Access Compliance Report

Public Rights-of-Way

(Curb Ramps)

Intersection ID: 49790	Main Street: FESCUE_CT	Cross Street: BARLEY_LN	Location: NW
ADA ID: B5793E3E984F	Ramp Type: Perp	Initial Pass/Fail: Pass	Overall Compliance: No
Severity Score: 5.25			
Codes/Mitigation Info/Possible Solution		Field Measurements/Component Compliance

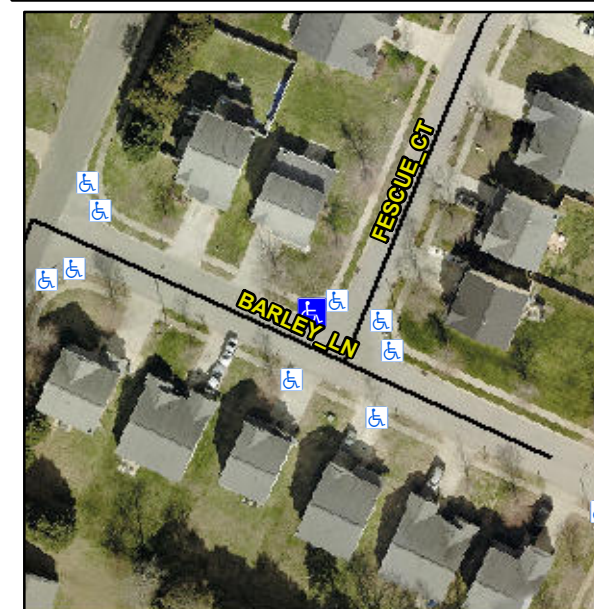
**Remove & Replace Entire Ramp.
Remove & Replace Gutter.**

**Not Found, R304.5.3, R304.2.1,
R304.5.4**
